**SUBJECT:** NuScale Power, LLC Supplemental Response to NRC Request for Additional Information No. 438 (eRAI No. 9491) on the NuScale Design Certification Application

NuScale Supplemental Response to NRC Request for Additional Information eRAI No. 9491

**eRAI No.:** 9491

**NRC Question No.:** 15.09-2

Figure 15.9-14: Time Trace of Pressure Boundary Function Representing the Effect of Decrease in Reactor Coolant Inventory

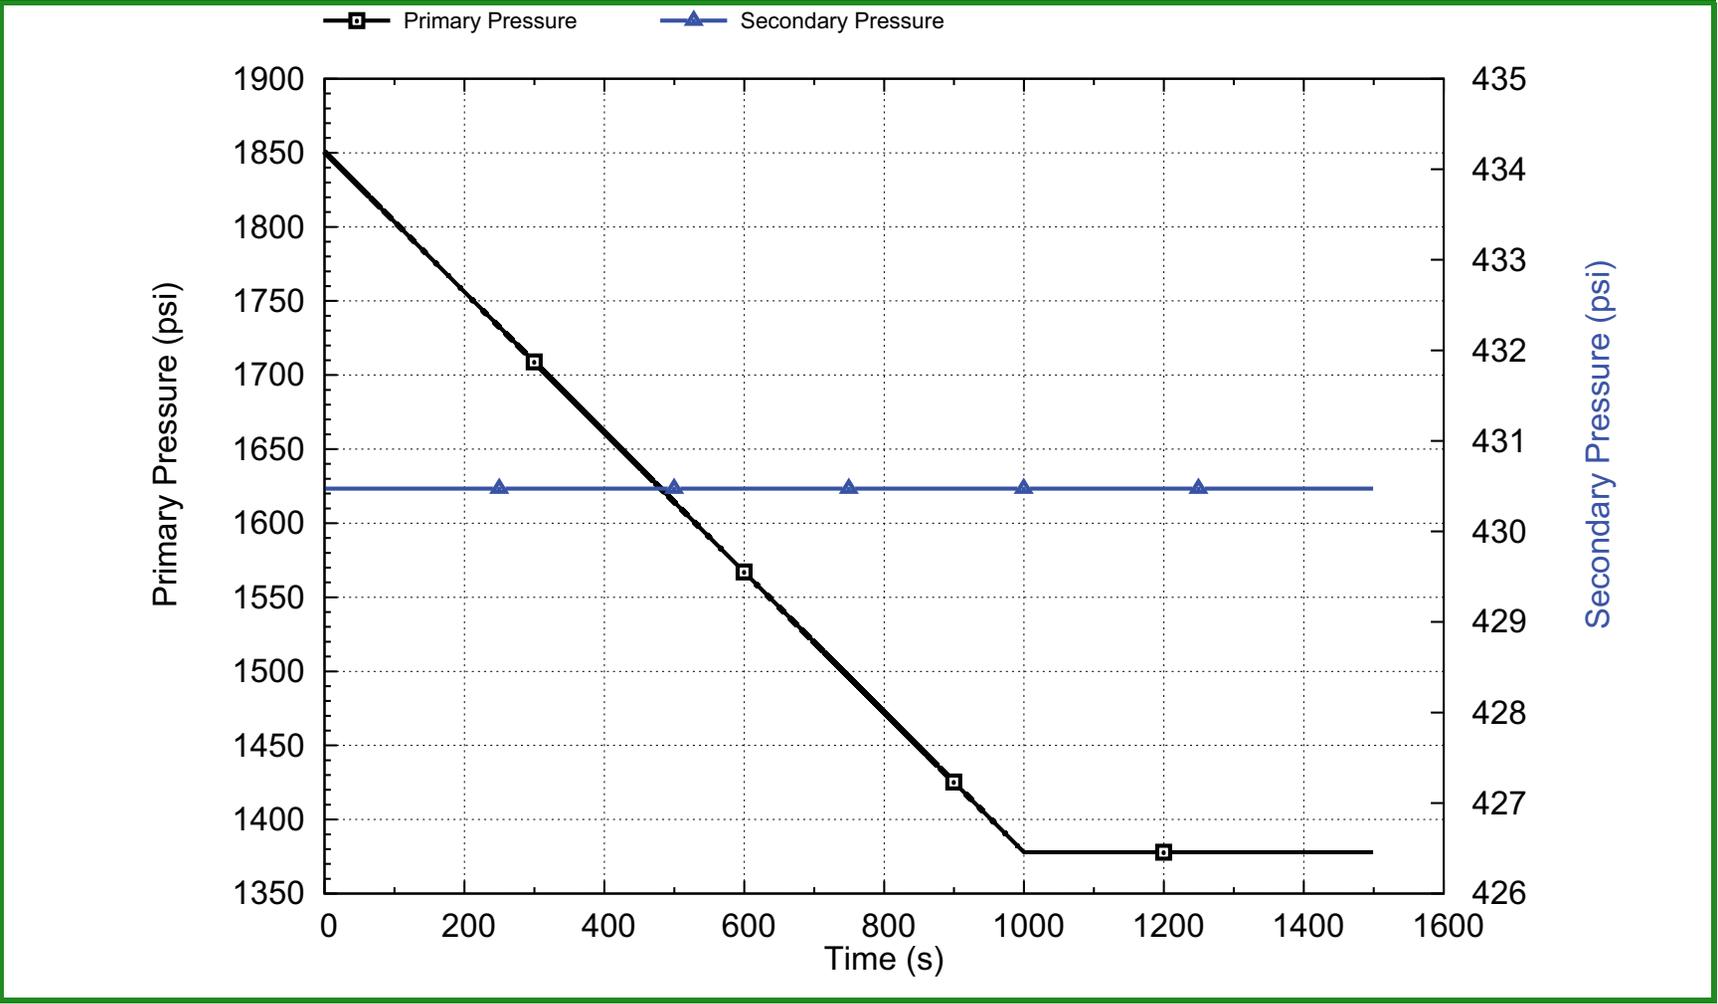
Reactor power is 160 MW when a slow depressurization of approximately 0.5 psi/second is imposed as a boundary forcing function. This depressurization is done over 1000 seconds, resulting in the pressure reaching 1378 psia. No systems operations occur in response to the event.

The results are presented in Figure 15.9-14 to Figure 15.9-17. The results show that the reactor would be safely shut down well before the development of oscillations due to loss of subcooling in the riser. A reactor trip would be initiated before these oscillations develop, the low-low pressurizer pressure trip once the pressure reaches 1600 psia.

**Figure 15.9-16: Time Trace of Power Response to a Decrease in Reactor Coolant Inventory at 100 Percent of Rated Power and Beginning of Cycle Reactivity**

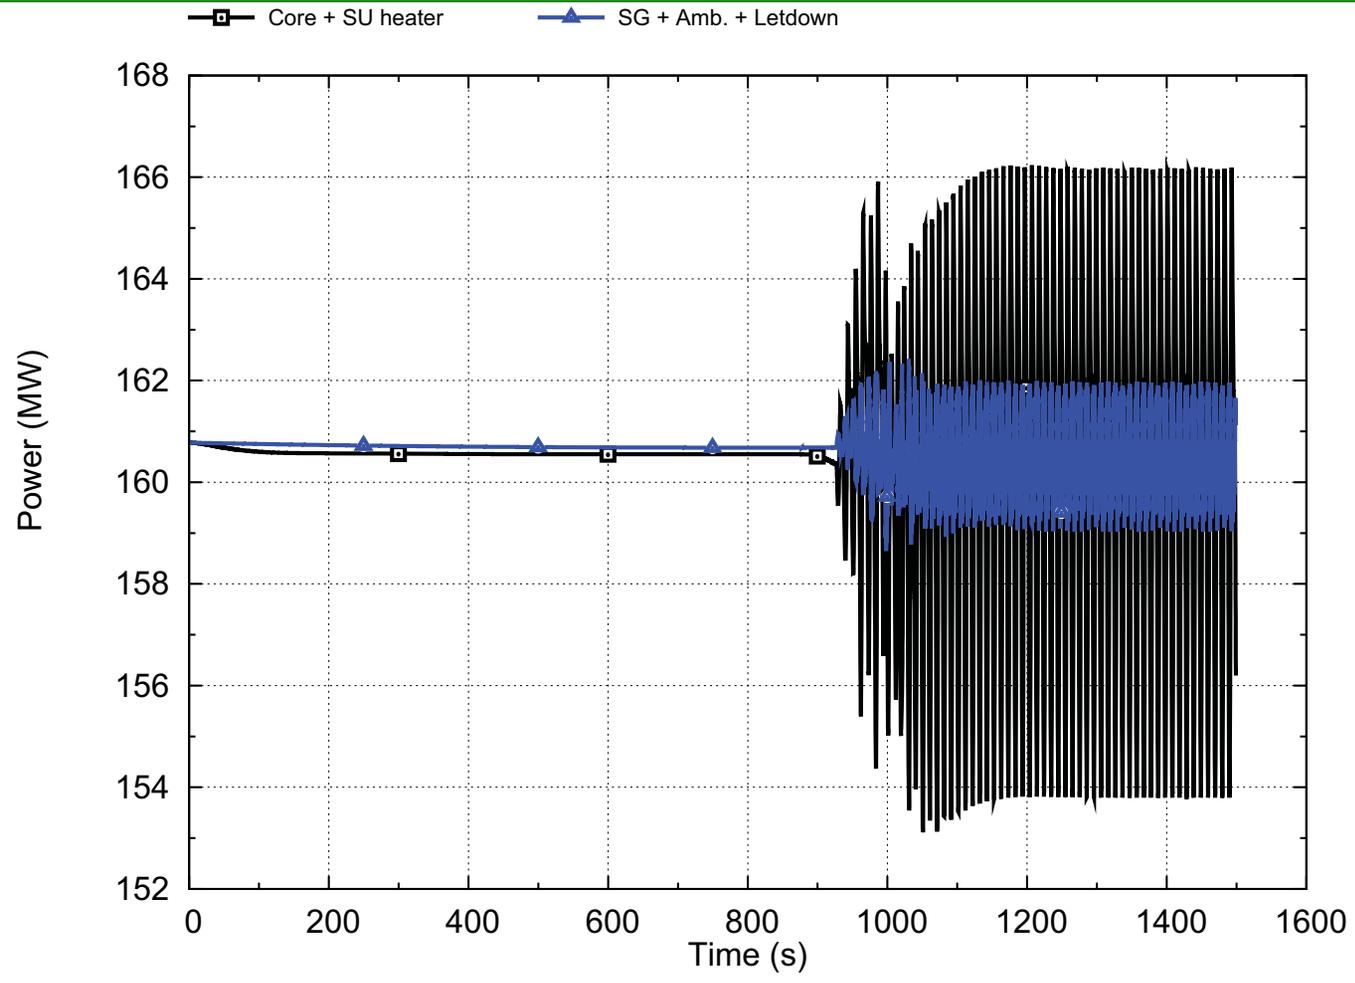
This trip would occur at approximately 530 seconds, while the oscillations begin to develop at approximately 927 seconds. The effect on CHF was found to be quantitatively similar for all exposure points. This response, as seen in Figure 15.9-17 for BOC, is an increase relative to the initial value. The increase of CHF is expected as a result of the increased natural circulation flow caused by voiding in the riser. This further confirms that this event is not a limiting event for stability.
